Body Fashion (PVT) Ltd.

Naogor kadda, Konabari, Gazipur, Dhaka.
(23.991440N, 90.356099E)

15 June 2014

High loading on floor slabs

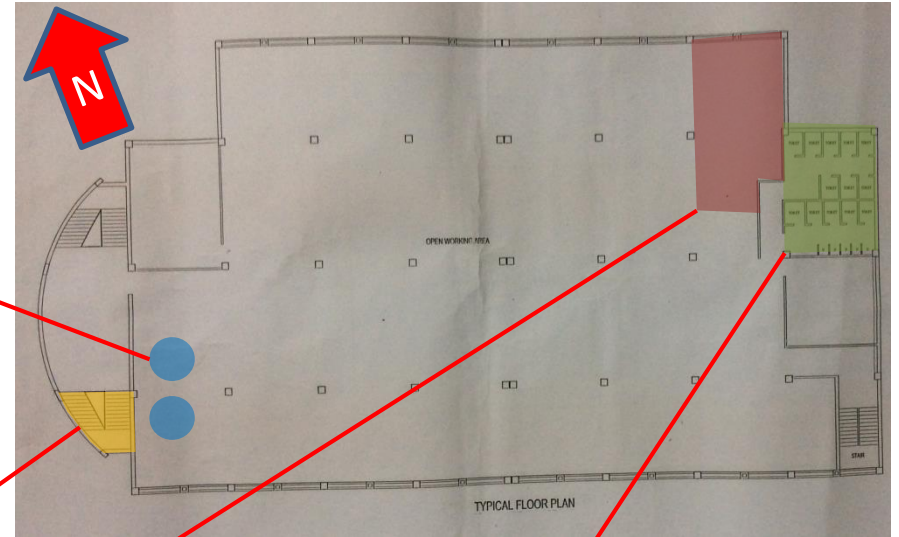
Design check required to assess the structural capacity of the floor slab to support (a) the toilet plinths and build-up, (b) the water tanks and (c) the yarn storage

Item No.	Observation	Recommended Action Plan	Recommended Timeline
9	Localised areas of high loading	As part of Detail Engineering Assessment (see Item 1), Building Engineer to check if beams/slabs have sufficient capacity to support fully-filled water tanks, toilet plinths & build-up, and yarn storage.	6-weeks
10	Localised areas of high loading	Continue to implement loading plan	6-months
11	New extension over entrance	As part of Detail Engineering Assessment (see Item 1), Building engineer to check the 1st floor slab for loading from brick piers under lateral and vertical load.	6-weeks
12	New extension over entrance	Building engineer to check lateral stability of extension and how it is connected to main building.	6-weeks
13	New extension over entrance	Implement any actions arising from checks.	6-months
14	Cracking in beams supporting roof	As part of Detail Engineering Assessment (see Item 1), Building engineer to investigate cause of cracking and the need for any remedial works / structural repairs	6-weeks

New extension over entrance

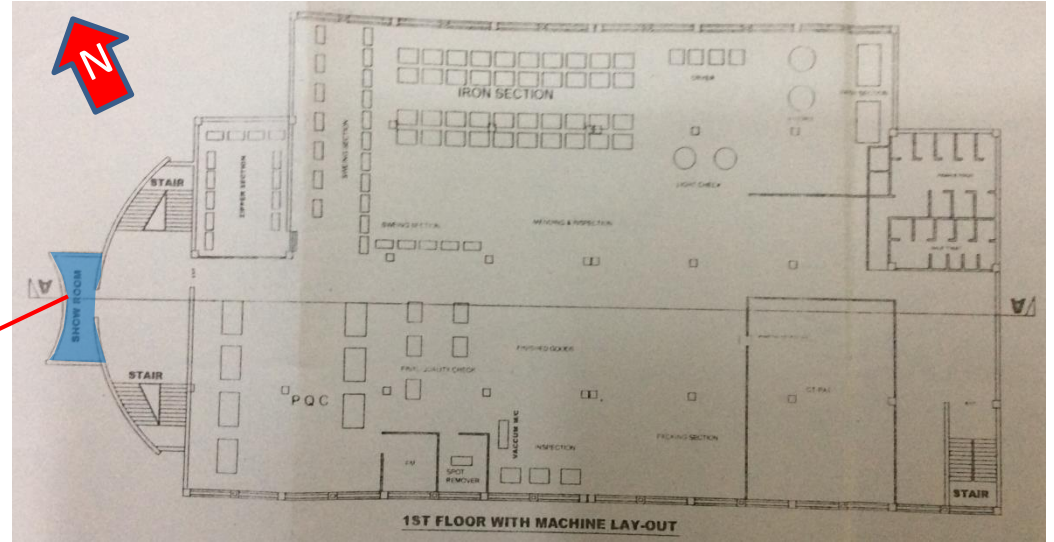
Structural capacity check required for floor extension at the West façade

Building engineer to check slab capable of carrying load from masonry piers.

Cracking in beams supporting roof slab

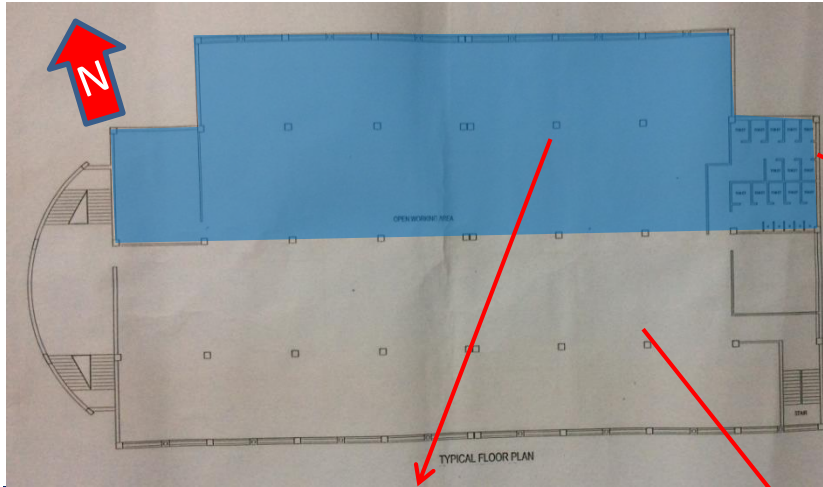
Repaired cracks on roof slab beams

Crack repairs on beams supporting roof slab

15	Cracking in beams supporting roof	Carry out remedial works / structural repairs as required.	6-months

Undocumented steel roof structure

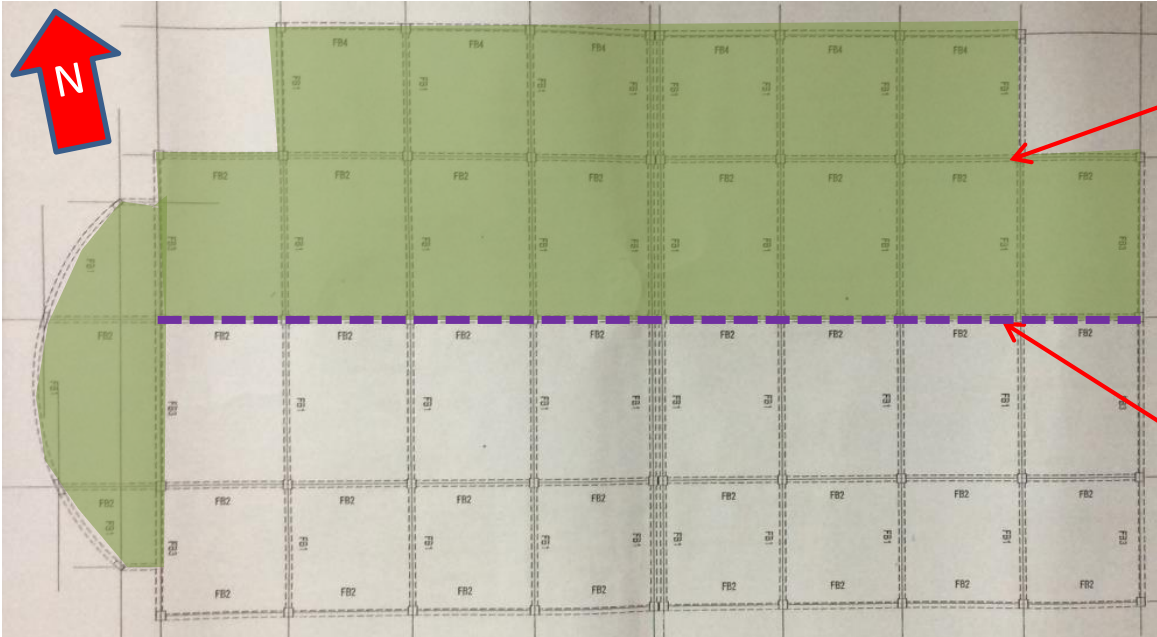
Structural capacity of steel roof elements to be checked

Highlighted part indicates steel roof area. Steel roof not shown on engineers drawings. In-plane bracing to be confirmed and checked by engineer.

Cladding frame with no secondary steel work

General note:
Limited access/visibility to steel roof structure. Load path and bracing system to be verified by building engineer.

Item No.	Observation	Recommended Action Plan	Recommended Timeline
16	Undocumented and lightweight roof structure	As part of Detail Engineering Assessment, Building Engineer to provide detailed calculations for the lightweight steel roof structure. These should confirm its ability to withstand all wind loading pressure, suctions and uplift forces.	6-weeks
17	Undocumented and lightweight roof structure	Implement any remedial works arising from Detail Engineering Assessment.	6-months
18	Undocumented and lightweight roof structure	Provide accurate as-built drawings.	6-months
19	RC beam size constructed on roof does not match the section size shown on the original drawings	As part of Detail Engineering Assessment, Building Engineer to provide detailed calculations for the roof beam noted above.	6-weeks
20	RC beam size constructed on roof does not match the section size shown on the original drawings	Carry out remedial works / strengthening to beam as required.	6-months

Non-engineered utility structures

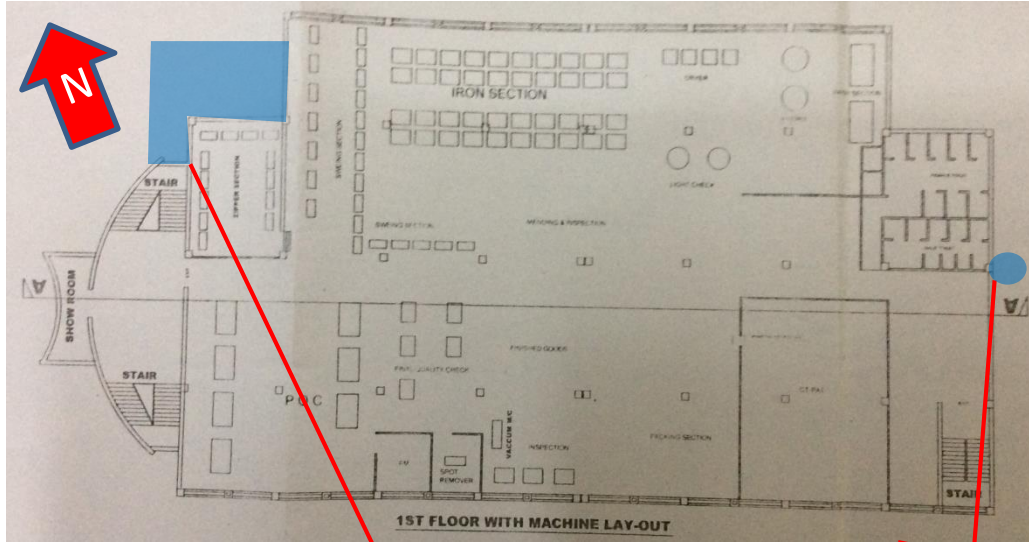
Structural capacity check required for non-engineered utility buildings surrounding main building

Brick building under construction on north-west side of main building. No record drawings. Building engineer to check.

Item No.	Observation	Recommended Action Plan	Recommended Timeline
21	Non-engineered utility structures	Utility structures to be checked by the Building Engineer for their capacity to withstand code vertical and horizontal loads	6-weeks
22	Non-engineered utility structures	Carry out remedial works as required, or vacate and remove.	6-months
23	Movement Joint at roof level	As part of Detail Engineering Assessment, movement joint details at roof level to be developed by Building Engineer.	6-weeks
24	Movement Joint at roof level	Carry out works to incorporate movement joint at roof level.	6-months

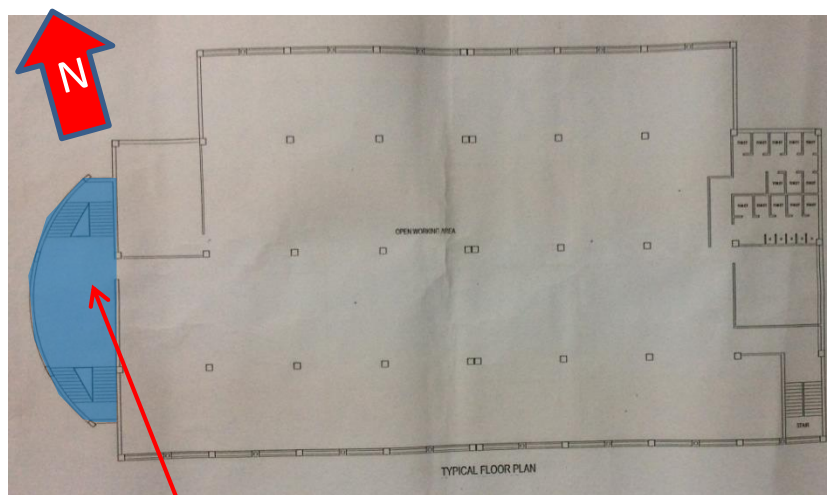
Steelwork supporting water tank at east façade.

Single storey brick building on south side of main building. No record drawings. Building engineer to check.

Structural capacity check required for non-engineered utility buildings surrounding main building

Steel roof supported by bamboo and rebar

Movement Joint

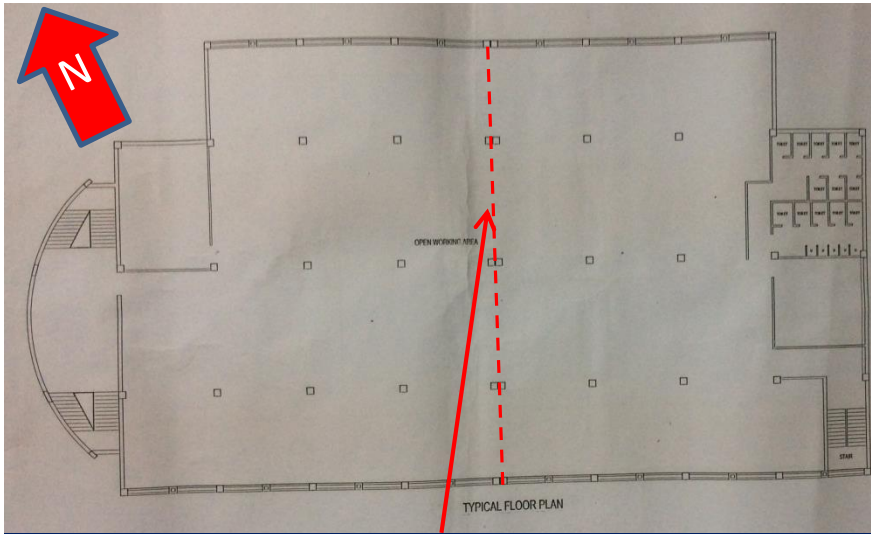
Movement joint not carried through at roof level and potentially prone to water ingress

Movement joint location

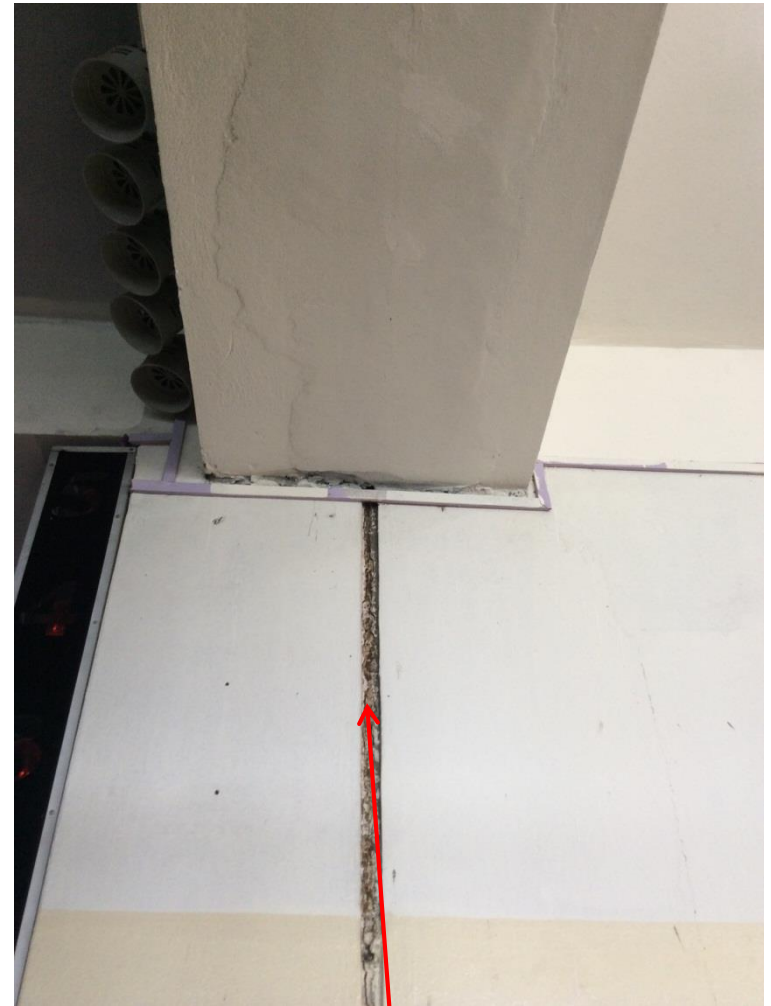
Movement joint on roof

Movement joint not apparent in beam supporting roof
